6th May 2024

## Wilderline to Duck River Plan Feedback

Thank you for the opportunity to comment on the Wilderline to Duck River Pedestrian and Cyclist Paths Draft Plan (*The Plan*).<sup>[1]</sup>

Marked-up Google Satellite view of the Marsh St and Parramatta Rd intersection with the proposed diagonal crossing.

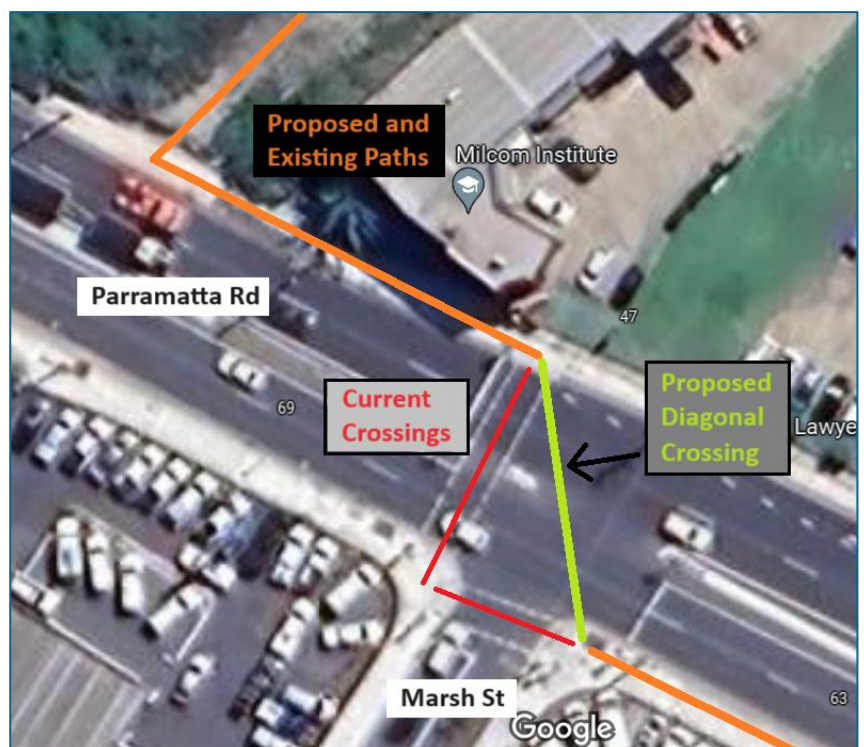
The main suggestion is to provide the ability to cross diagonally at the Marsh St and Parramatta Rd intersection as well as straight across. This would require traffic to be stopped on both Parramatta Rd and Marsh St. Ideally traffic could be stopped at relatively short notice, without the normal lengthy delays until the next traffic signal change.

We feel this would be a practical implementation of the Road User Hierarchy<sup>[2]</sup>, where other road (corridor) users can temporarily take priority over motorised vehicles instead of always having to fit around the predefined traffic light cycles and vehicle movement priorities.

Example of a raised priority crossing.<sup>[3]</sup>

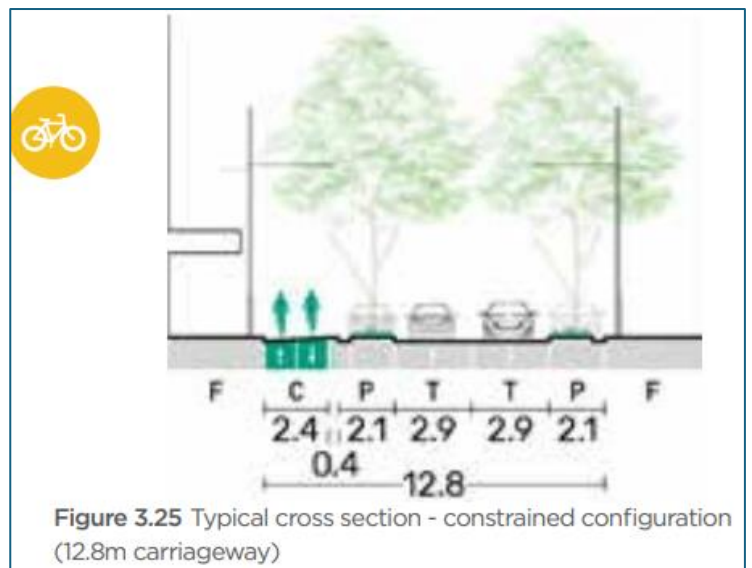
Would making the George St crossing a raised priority cyclist and pedestrian crossing be an option? There's already a left turn lane off Parramatta Rd into George St, so vehicles turning should already be out of the main carriageway flow.
